## Planning Commission Staff Report

Case No.: 3.3215 MAJ

Type: Major Architectural Application

Location: 3900 East Vista Chino Road

SCALE: 1" = 40'-0"  
 PROJECT NO: 0612  
 FILE: 612-40SITE  
 SHEET  
**A-1.1**

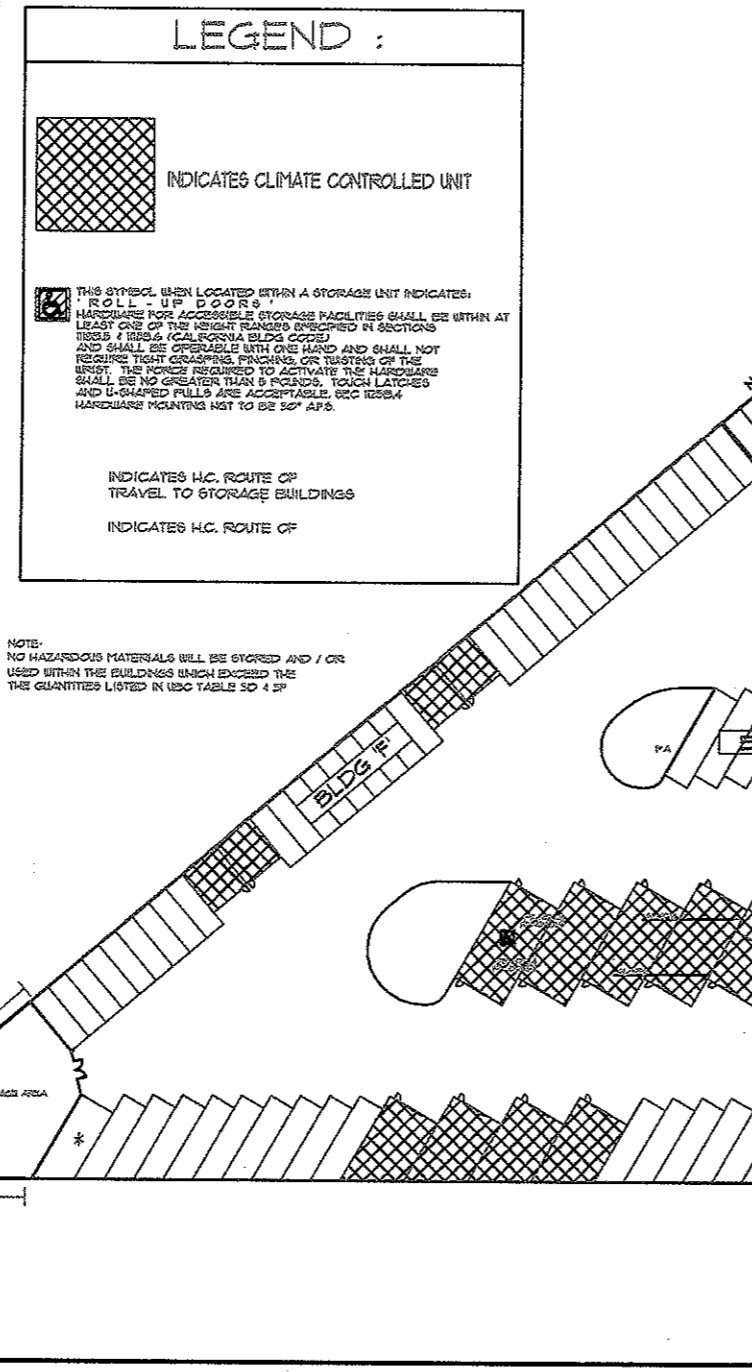
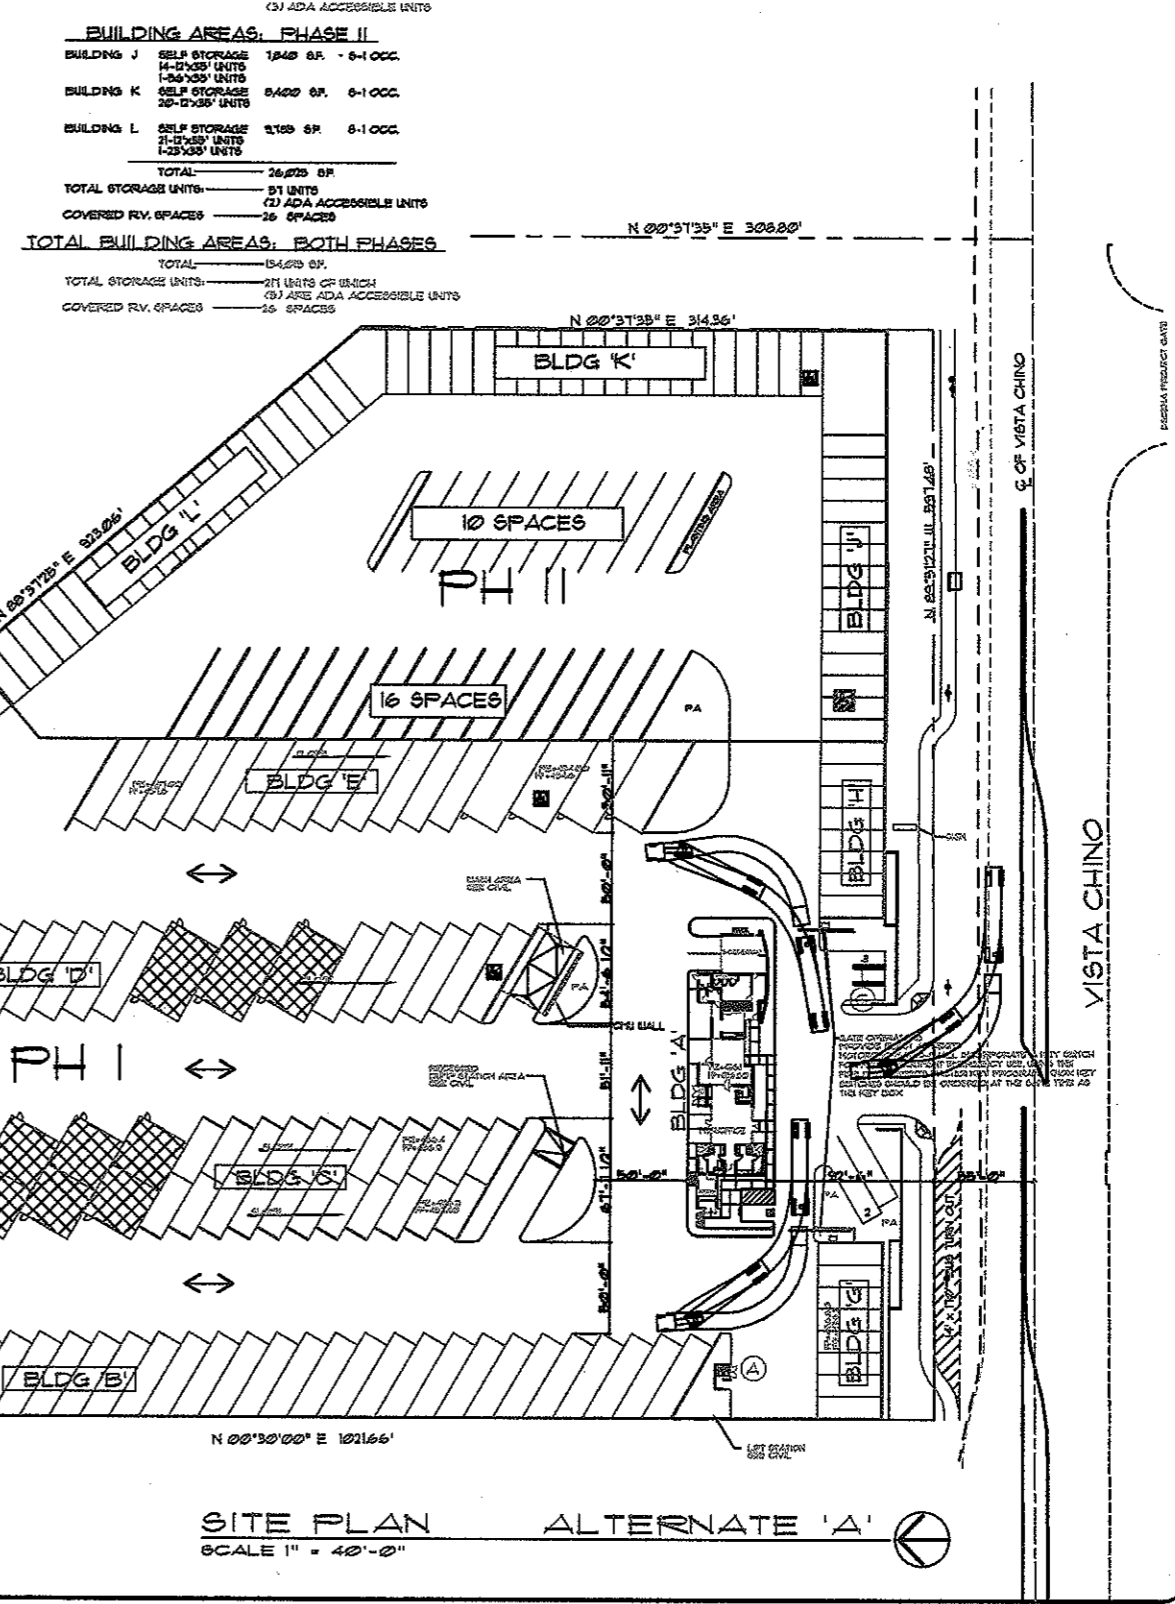
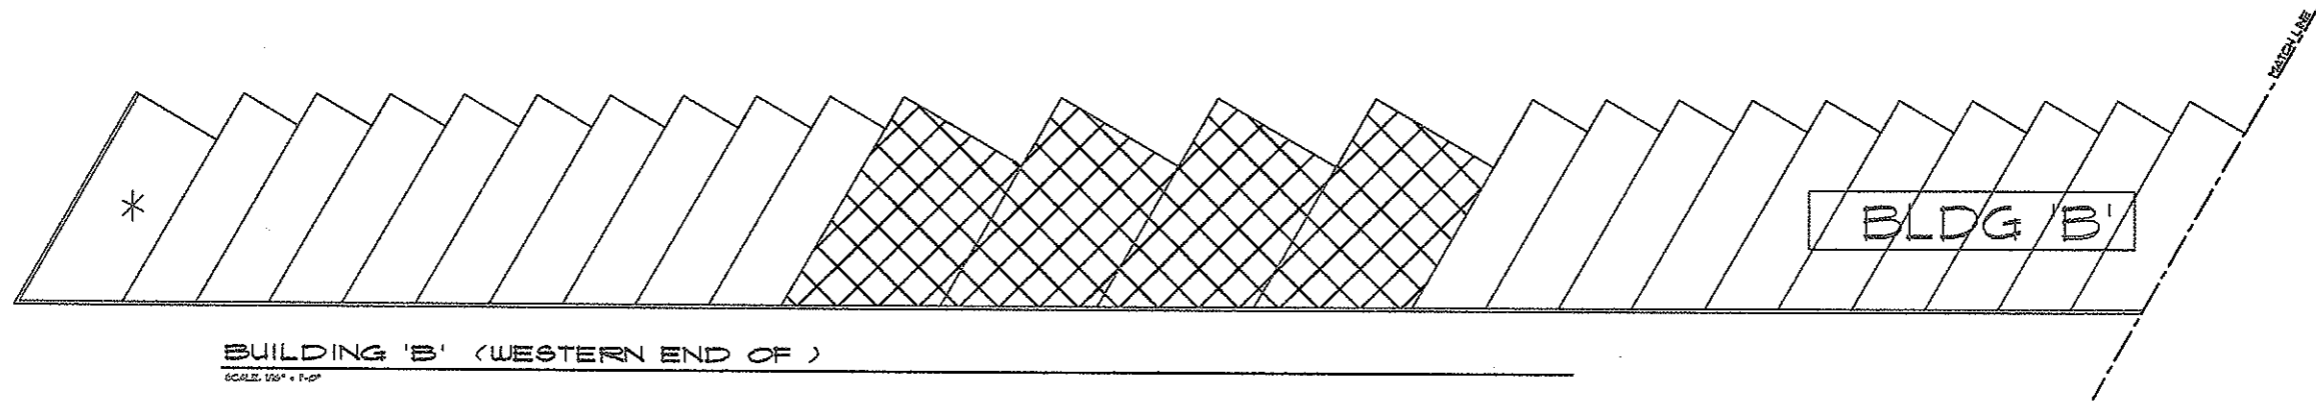
- ENG 15. The applicant is advised that the proposed site plan and preliminary grading plan show construction of a 3 to 4 feet deep retention basin along the entire frontage of the property, adjacent to Vista Chino. Construction of retention basins that exceed 50% of the frontage of a property are not allowed. The applicant shall obtain specific approval from the Planning Commission for construction of retention basins exceeding the 50% frontage limitation, or otherwise shall be required to revise the proposed site plan and preliminary grading plan to conform to the 50% frontage limitation.
